Nine Mile Point Unit 2 Docket No. 50-410 NPF-69 TAC No. MB0301

Subject: Proposed Technical Specification Changes - Excess Flow Check Valve Testing

APPLICATION FOR AMENDMENT TO OPERATING LICENSE

Proposed Changes to Technical Specifications

SUBVETLIANCE REQUIREMENTS (continued)

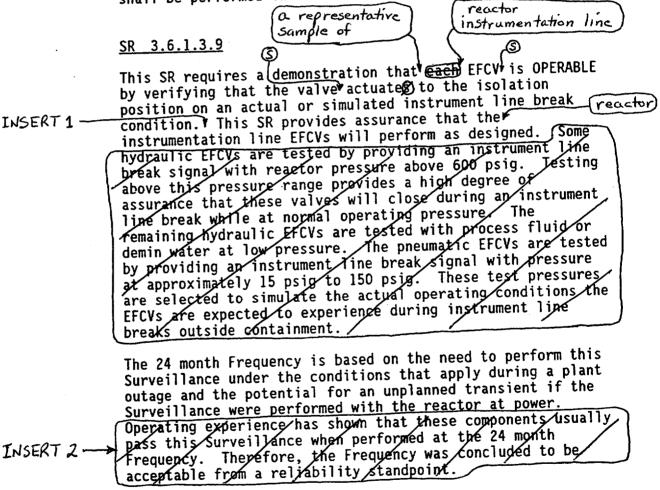
The NRC approved on February 15, 1999, as Amendment 91 to the Operating License, conversion of NMP2's TS to the improved TS (ITS) standard format. Prior to converting to ITS, the EFCV SR (4.6.3.4) required that "Each reactor instrumentation line excess flow check valve shall be demonstrated OPERABLE..." The Bases referenced a listing of primary containment isolation valves which included both the EFCVs in the instrumentation lines connected to the RCPB and those in other instrument lines. NMPC's practice of testing all of the listed EFCVs was carried forward in the ITS conversion process. NUREG-1434 (for BWR 6s) was used as the template for the conversion, but it does not address EFCVs. In providing a plant specific SR to reflect NMP2 (BWR 5) design and surveillance requirements, NMPC deleted the words "reactor instrument line EFCVs. Although it has been, and will continue to be, NMPC's practice to test all instrument line EFCVs, it is not appropriate, for reasons described above, to include EFCVs other than those in reactor instrumentation lines in the scope of the SR. Therefore, it is proposed that the words "reactor instrumentation line" be reinserted in SR 3.6.1.3.9.

It is proposed that the requirement for testing of EFCVs other than those in reactor instrumentation lines be relocated to the Inservice Testing (IST) Program where it currently exists as a refueling outage frequency. The IST Program, required by 10CFR50.55a, provides requirements for the testing of all American Society of Mechanical Engineers Code Class 1, 2, and 3 valves in accordance with applicable codes, standards, and relief requests, endorsed by the NRC for NMP2. These controls are adequate to ensure the required testing of these EFCVs is performed and do not need to be in the TS to provide adequate protection of the public health and safety. Changes to the relocated requirements in the IST Program will be controlled by the provisions of 10CFR50.55a.

JRVEILLANCE RE	SURVEILLANCE	FREQUENCY
SR 3.6.1.3.6	Perform leakage rate testing for each primary containment purge valve with resilient seals.	184 days <u>AND</u> Once within
		92 days after opening the valve
SR 3.6.1.3.7	Verify the isolation time of each MSIV is \geq 3 seconds and \leq 5 seconds.	In accordance with the Inservice Testing Program
SR 3.6.1.3.8	Verify each automatic PCIV actuates to the isolation position on an actual or simulated isolation signal. <u>Freactor instrumentation line</u>	24 months
representativ	a sample of	
SR 3.6.1.3.9	Verify EFCV actuates to the isolation position on an actual or simulated instrument line break signal.	24 months
SR 3.6.1.3.1	0 Remove and test the explosive squib from each shear isolation valve of the TIP System.	24 months on a STAGGERED TEST BASIS
SR 3.6.1.3.1	I Verify the leakage rate for the secondary containment bypass leakage paths is within the limits of Table 3.6.1.3-1 when pressurized to ≥ 40 psig.	WITH TO OUR OF

INSERT 1

The representative sample consists of an approximately equal number of reactor instrumentation line EFCVs, such that each EFCV is tested at least once every 5 refueling cycles. In addition, the reactor instrumentation line EFCVs in the sample are representative of the various plant configurations, models, sizes, and operating environments. This ensures that any potentially common problem with a specific type or application of reactor instrumentation line EFCV is detected at the earliest possible time.

INSERT 2

The nominal 10-year interval is based on performance testing as discussed in NEDO-32977-A, "Excess Flow Check Valve Testing Relaxation" (Ref. 8). Furthermore, any reactor instrumentation line EFCV failures will be monitored in accordance with the Maintenance Rule Program to ensure overall reliability is maintained. Appropriate corrective actions will be taken if failures exceed the established performance criteria. Operating experience has demonstrated that these components are highly reliable and that failures to isolate are very infrequent. Therefore, testing of a representative sample was concluded to be acceptable from a reliability standpoint.
